Iowa DAS - DOC 4JD CBC New Central Office Building

Addendum #01

Dated: April 30, 2026

ADDENDUM NUMBER ONE
To Contract Documents for:
IOWA DAS – DOC 4JD CBC NEW CENTRAL OFFICE BUILDING
SVPA Project No. 25079
Owner Project No. 9488.00

5 BUILDING SECTION
SCALE: 1/8" = 1'-0"

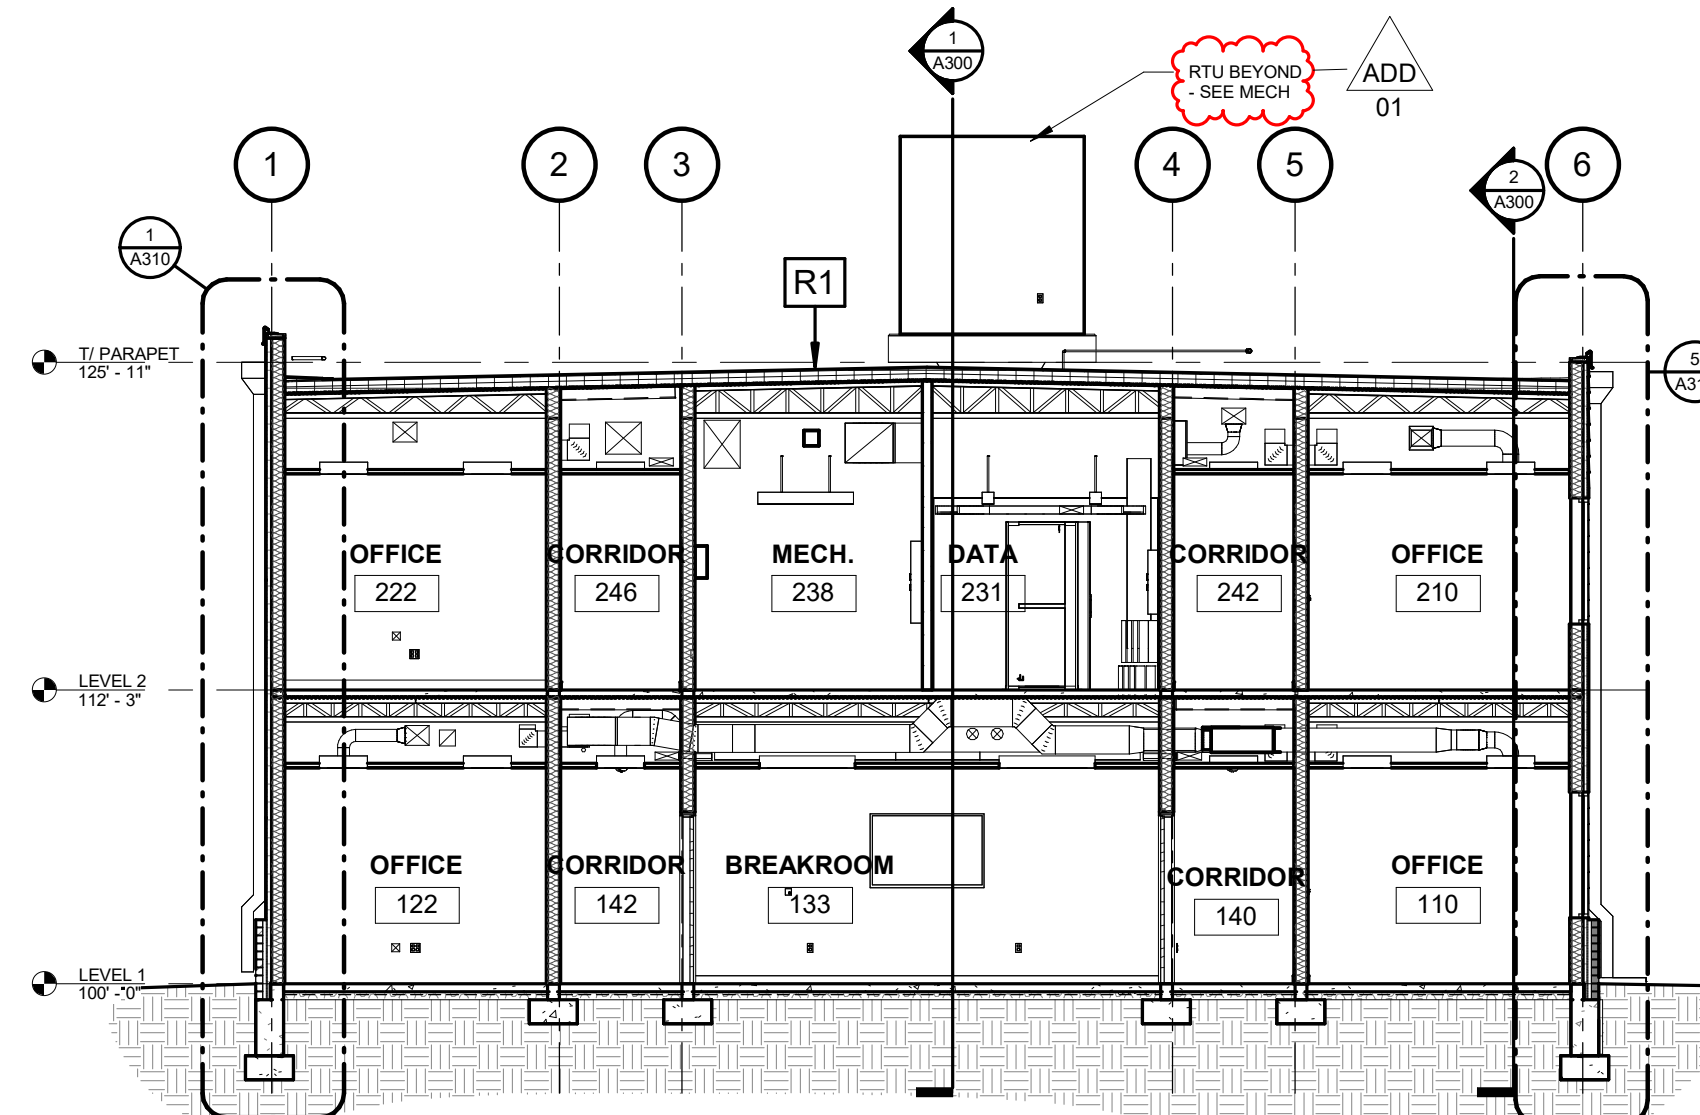
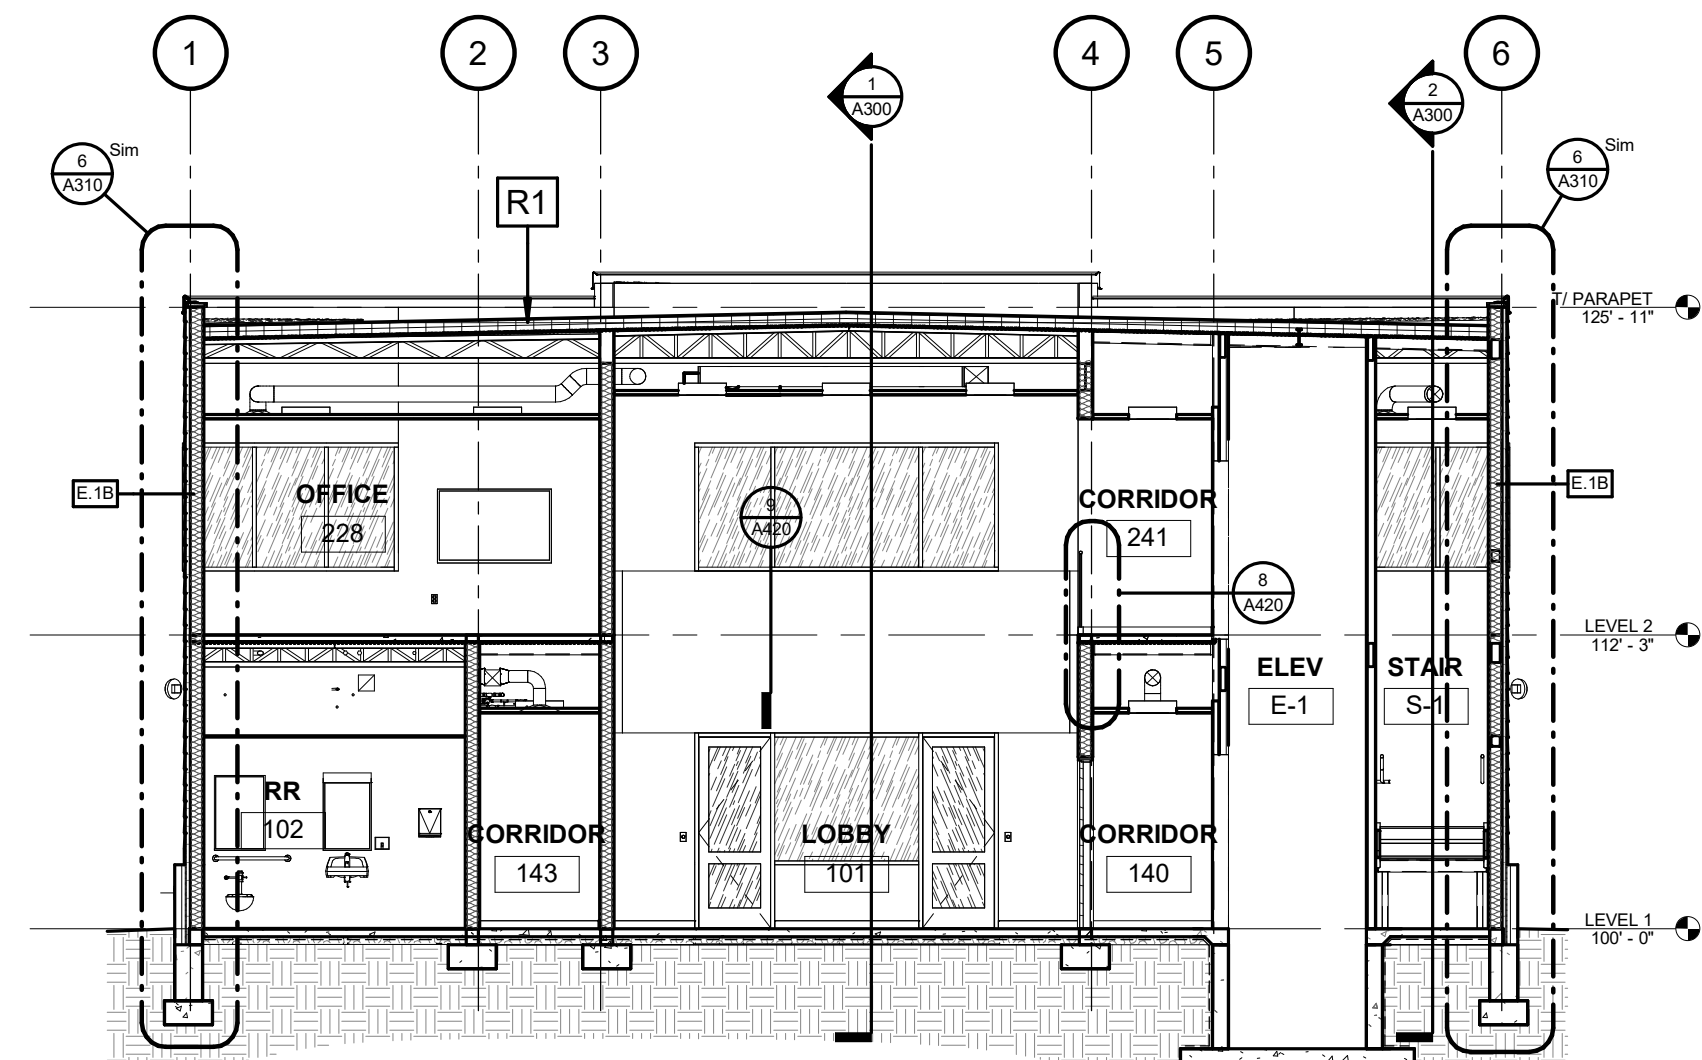
- A. ADD note “RTU BEYOND – SEE MECH” to BUILDING SECTION 4.
- B. REMOVE dimension string in View 5.
- C. ADD detail 7/A110 and VEST to BUILDING SECTION 5.
- D. See attached revised sheet A300.

5 CANOPY CONNECTION
SCALE: 1 1/2" = 1'-0"

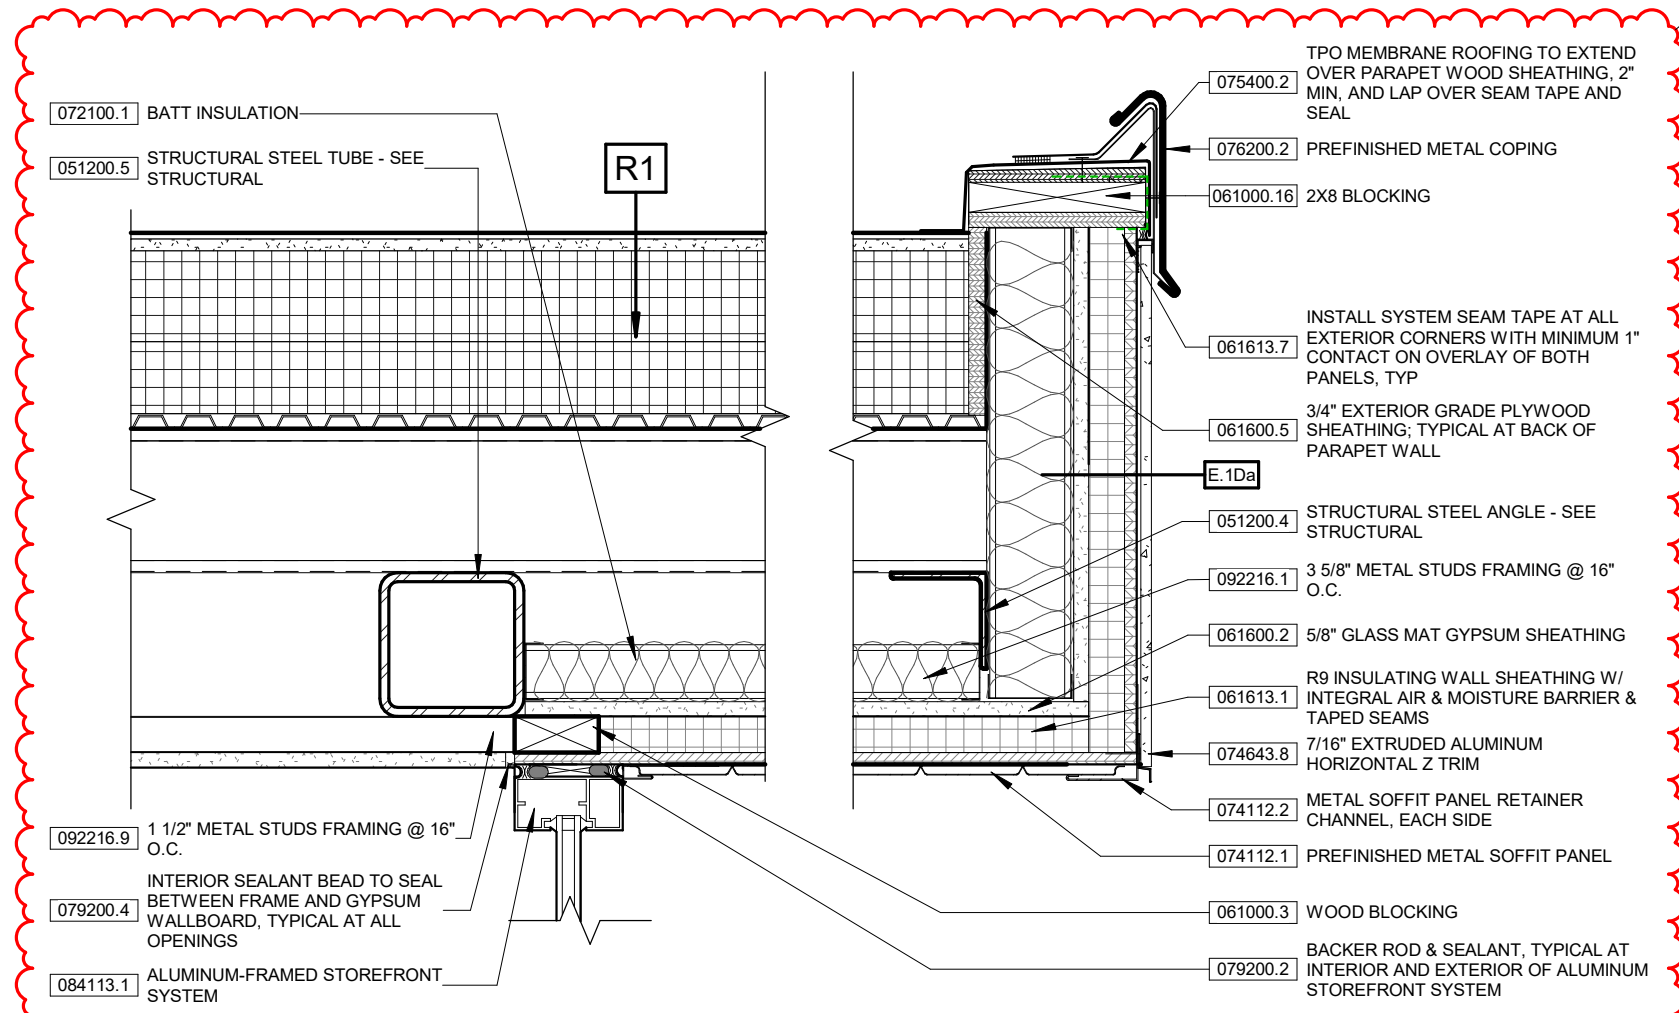
- A. ADD details 6 and 7 to sheet.
- B. REVISE structural connection at detail 5, CANOPY CONNECTION.
- C. ADD roof tag to detail 4.
- D. ADD insulation and keynotes to detail 3 LOW CANOPY FASCIA DETAIL.
- E. REMOVE wall tag from detail 2.
- F. See attached revised sheet A511.

1 LEVEL 1
SCALE: 1/8" = 1'-0"

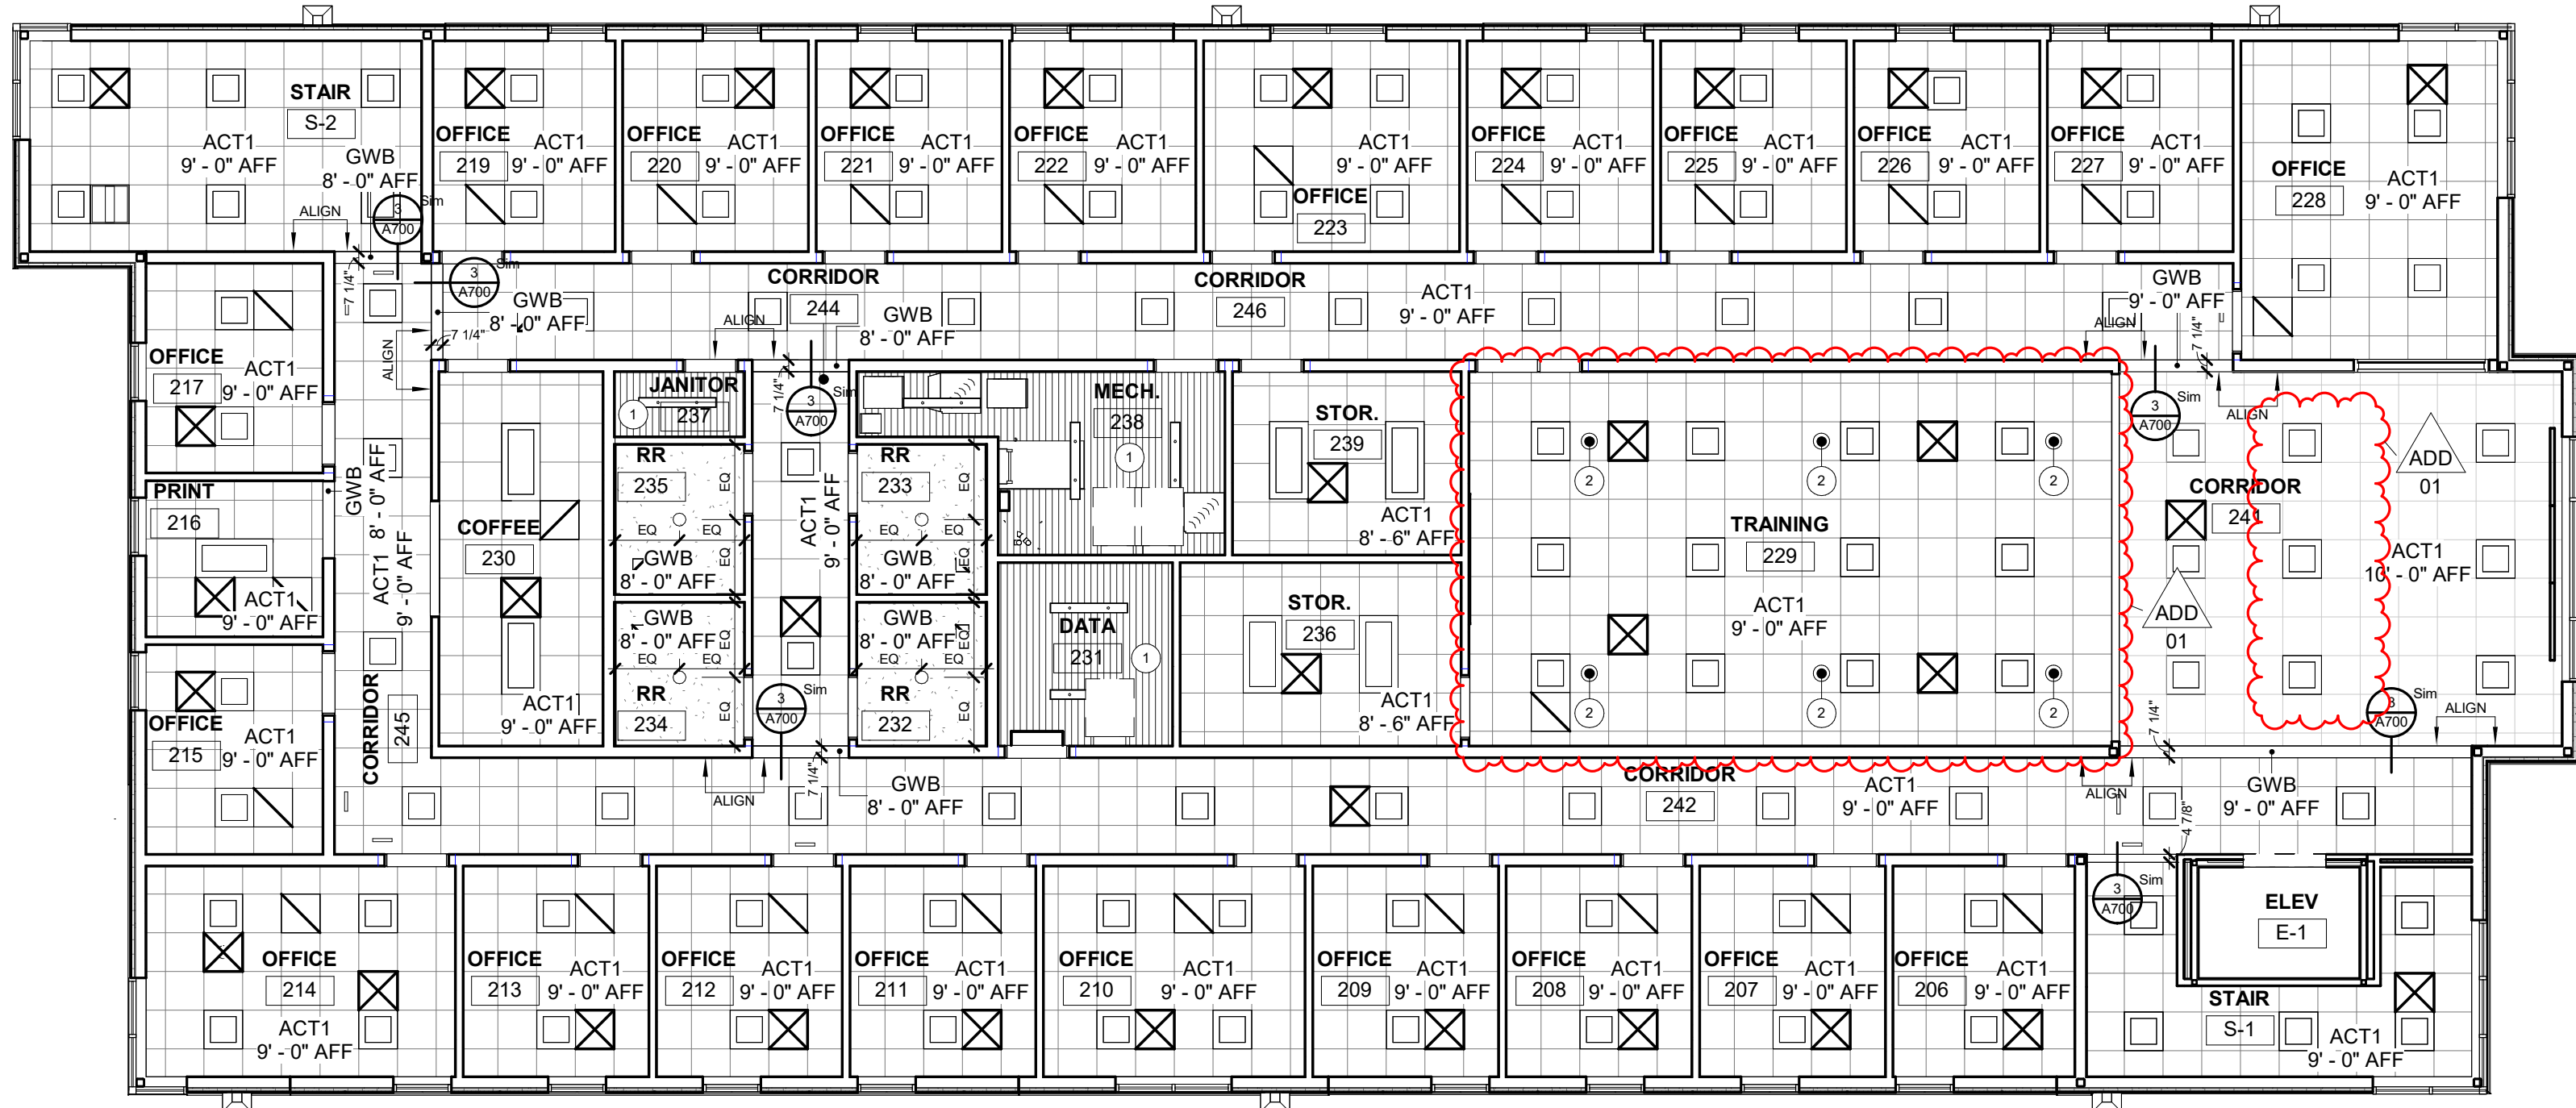
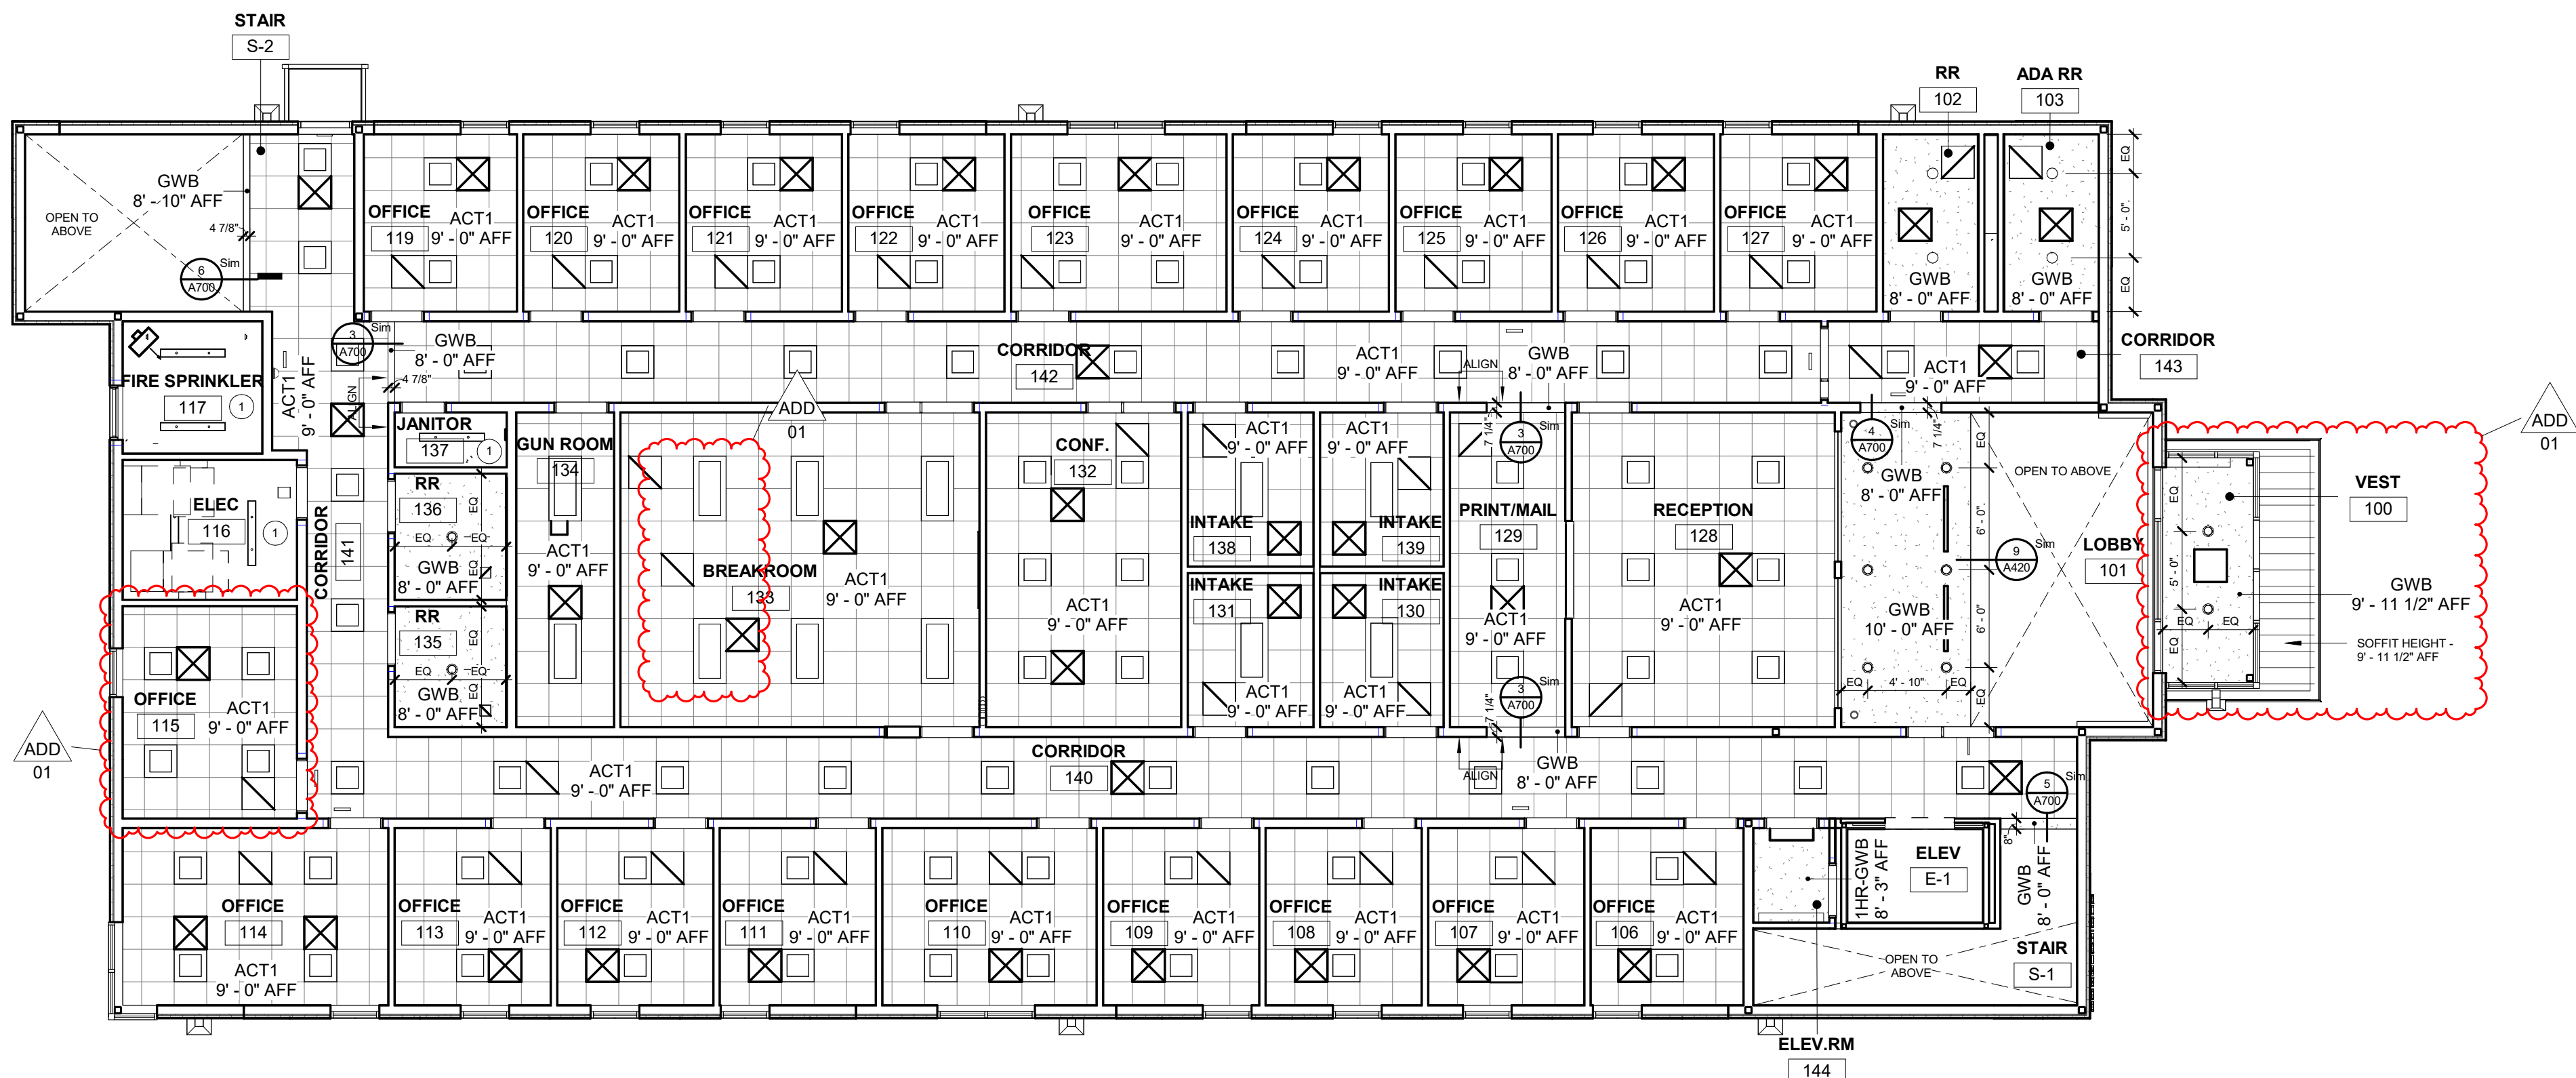
- A. REVISE speaker and light locations.
- B. ADD note 2 to Reflected Ceiling Plan Notes.
- C. ADD soffit to canopy.
- A. See attached revised sheet A700.
